Architectural Review Board Staff Report
August 8, 2022

14 SOUTH HIGH STREET BUILDING ADDITION
CERTIFICATE OF APPROPRIATENESS

LOCATION: 14 South High Street (PID: 222-000001)
APPLICANT: Keiser Design Group Inc, c/o Ethan Frazier
REQUEST: Certificate of Appropriateness
ZONING: Urban Center, Historic Center
STRATEGIC PLAN: Village Center
APPLICATION: ARB-84-2022

14 S. HIGH ST., NEW ALBANY, OH 43054
PROPOSED EXTERIOR ELEVATIONS

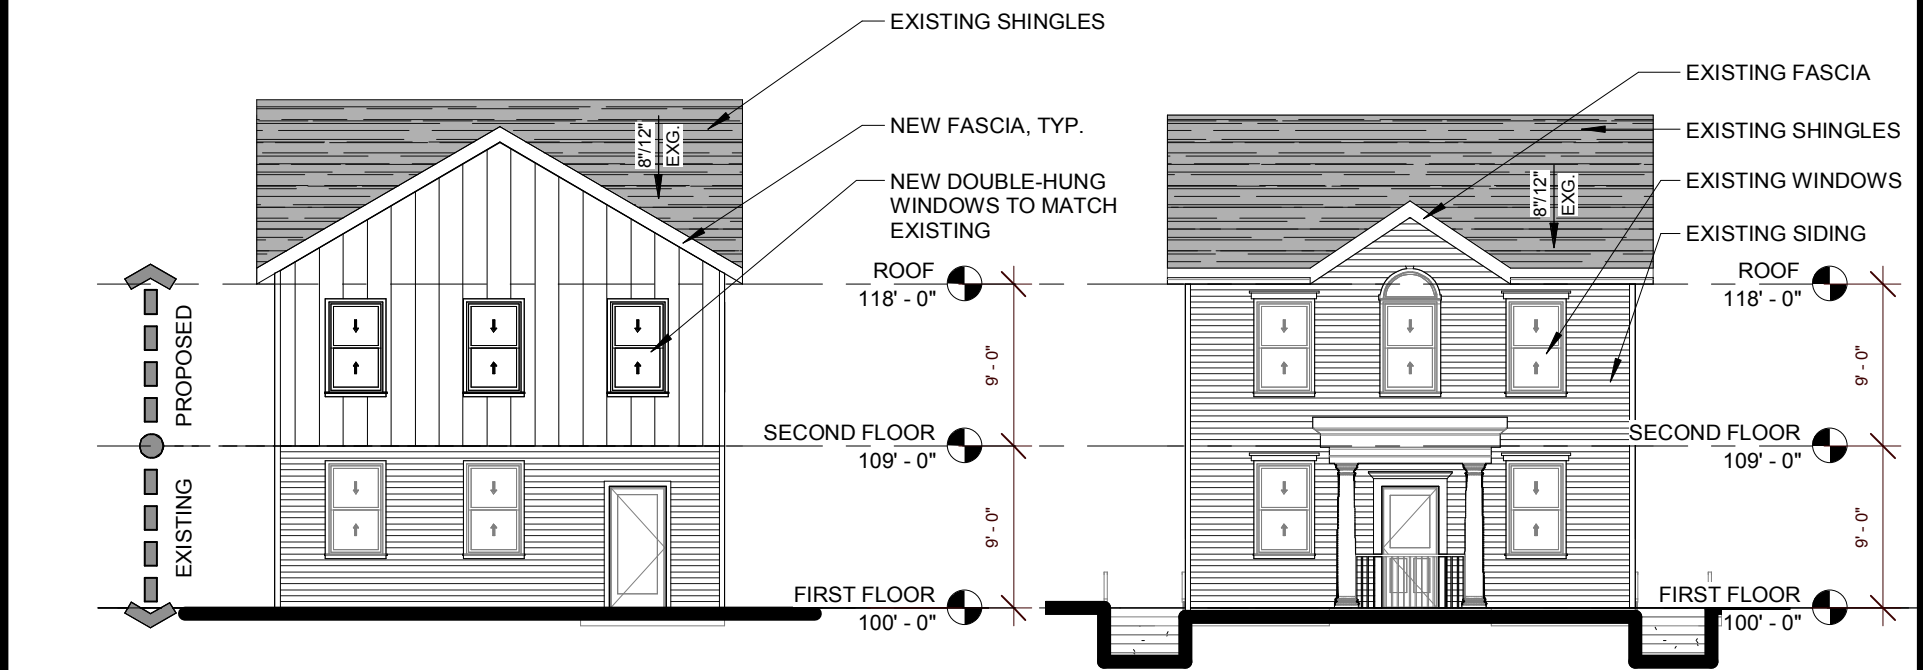
- The new two-story wall will be flush with the side wall of the original structure. The new fascia matches the existing fascia. The plans include new double-hung windows to match the existing windows. The applicant proposes to utilize gray roof shingles on the addition that match the existing shingles. The applicant included a digital sample material board with their application documents.

- The city architect has reviewed the application and comments that since the addition is a full two-story height structure, it doesn't feel as if the renovation relates to the existing design as much as it should. The city architect recommends the following revisions:

- The visual break between the existing portion and new addition needs to happen at the eave.
 - The roof pitch of the existing structure and new addition are to match.

- Shed roof dormers are to be added with a 4:12 pitch.

- The addition is to have a 7' tall knee wall between the existing one-story portion of the structure and the new roof for the addition.
- Staff recommends a condition of approval that all comments from the city architect are satisfied, subject to staff approval. The city architect created the following sketch to indicate what additional detailing he recommends:

- DGR section 2(II.C.3) states "the height of building wings and dependencies shall not exceed the height of the roof peak of the main portion of the building." Based on the recommended changes from the city architect, this requirement will be met.

1. That the applicant must revise the design and drawings per the city architect's comments and the rendering provided, subject to staff approval.
2. The existing horizontal vinyl siding be replaced with horizontal Hardie board material.

DIGITAL SAMPLE MATERIAL BOARD

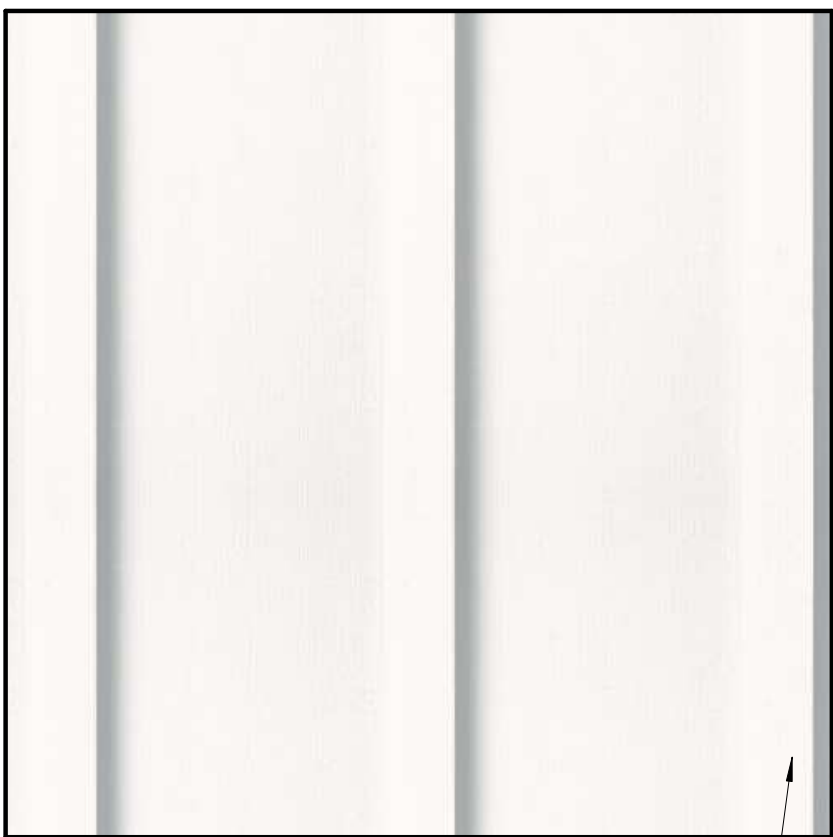
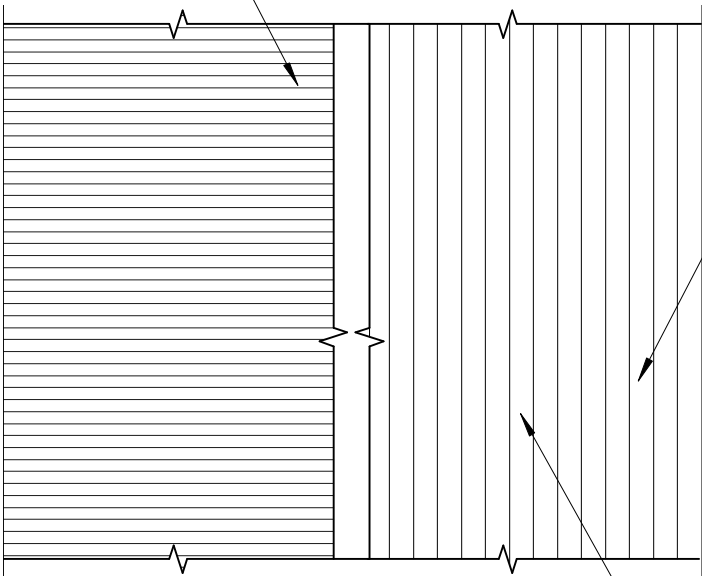
- The applicant proposes a white board and batten style siding on the addition that is consist with the way traditional materials would have been used. The applicant proposes to use Hardie panel board (fiber cement) for the boards and thin strips of wood molding for battens. A digital sample material board has been submitted which shows the proposed Hardie panel board material having similar surface texture as wood. Hardie panel board has been used successfully in other parts of the Village Center.

- The applicant proposes to remove and replace the existing vinyl siding with Hardie panel board and batten on the existing portions of the building.
 - The city architect recommends that the applicant retain the horizontal siding pattern with new Hardie board material. The city architect states that this approach helps to differentiate between old and new.

- Based on the city architect's comment, staff recommends a condition of approval that the existing horizontal vinyl siding be replaced with horizontal Hardie board material.
